Economic Commission for Europe**Inland Transport Committee****World Forum for Harmonization of Vehicle Regulations****One-hundred-and-fifty-second session**

**1958 Agreement – Consideration of draft corrigenda
to existing Regulations proposed by GRPE****Proposal for a Corrigendum 1 to Supplement 7 to the 05
series of amendments to Regulation No. 83
(Emissions of M₁ and N₁ vehicles)****Submitted by the Working Party on Pollution and Energy***

“Figure 13

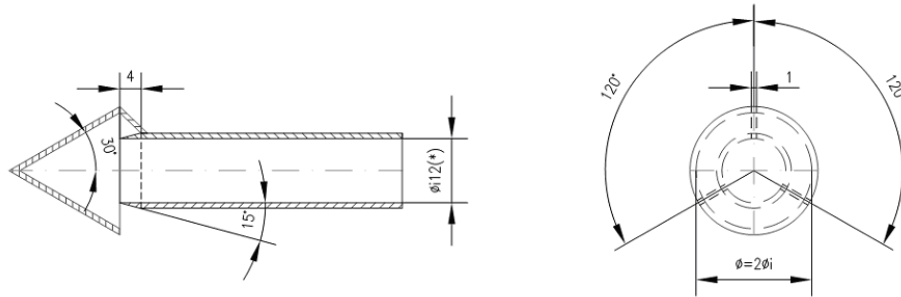
Annex 4a, Appendix 4, Figure 13, amend to read:

Particulate sampling probe configuration

(*) Minimum internal diameter
Wall thickness ~ 1 mm - Material: stainless steel
